Access Compliance Report

Public Rights-of-Way

(Curb Ramps)

Intersection ID: 45860	Main Street: FRYE_PL	Cross Street: HENDERSON_OAKS_DR	Location: SE
ADA ID: 619F6759A345	Ramp Type: PerpDiag	Initial Pass/Fail: Fail	Overall Compliance: No
Severity Score: 33.75			
Codes/Mitigation Info/Possible Solution		Field Measurements/Component Compliance

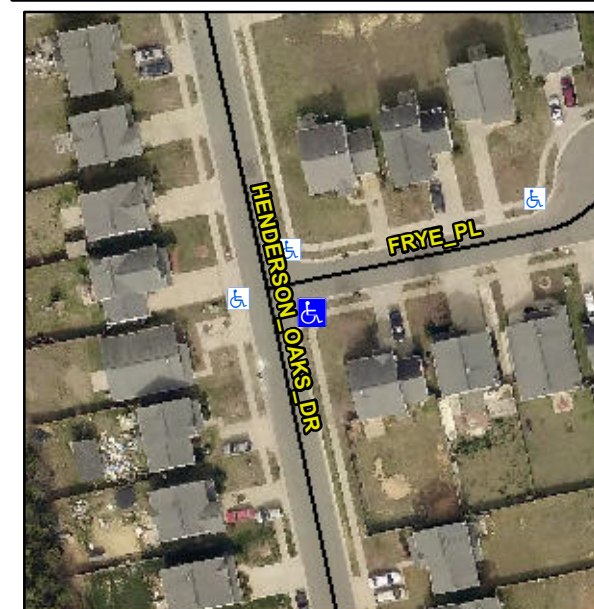
Not Found, R304.5.1, R304.2.2

Compliance	Description	Data	Compliance	Description	Data
N/A	Ramp Length (in)	48.0	No	Ramp Slope (%)	14.1
No	Ramp Width (in)	36.0	Yes	Ramp XSlope (%)	1.3
N/A	Flare Type LT	N/A	N/A	Flare Type RT	N/A
N/A	Flare Slope LT (%)	N/A	N/A	Flare Slope RT (%)	N/A
N/A	Flare Traversable LT?	N/A	N/A	Flare Traversable RT?	N/A
N/A	Landing Length (in)	N/A	N/A	DWS Provided?	N/A
N/A	Landing Width (in)	N/A	N/A	DWS Contrast?	N/A
N/A	Landing Slope (%)	N/A	N/A	DWS Length (in)	N/A
N/A	Landing X Slope (%)	N/A	N/A	DWS Full Width?	N/A
N/A	Landing Curb? (Y/N)	N/A	N/A	DWS Offset (in)	N/A
N/A	Shared Landing?	N/A			
N/A	Gutter Ponding?	N/A	N/A	Gutter Slope (%)	N/A
N/A	Gutter Lip Ht (in)	N/A	N/A	Gutter X Slope (%)	N/A
N/A	Painted X Walk1?	No	N/A	Painted X Walk2?	No
	X Walk 1 Direction	To N		X Walk 2 Direction	To W
N/A	X Walk 1 Width (in)	N/A	N/A	X Walk 2 Width (in)	N/A
	X Walk 1 Slope (%)	1.0		X Walk 2 Slope (%)	0.5
	X Walk 1 X Slope (%)	0.1		X Walk 2 X Slope (%)	0.4

Remove & Replace Curb Ramp With Two New Directional Ramps or Equivalent.
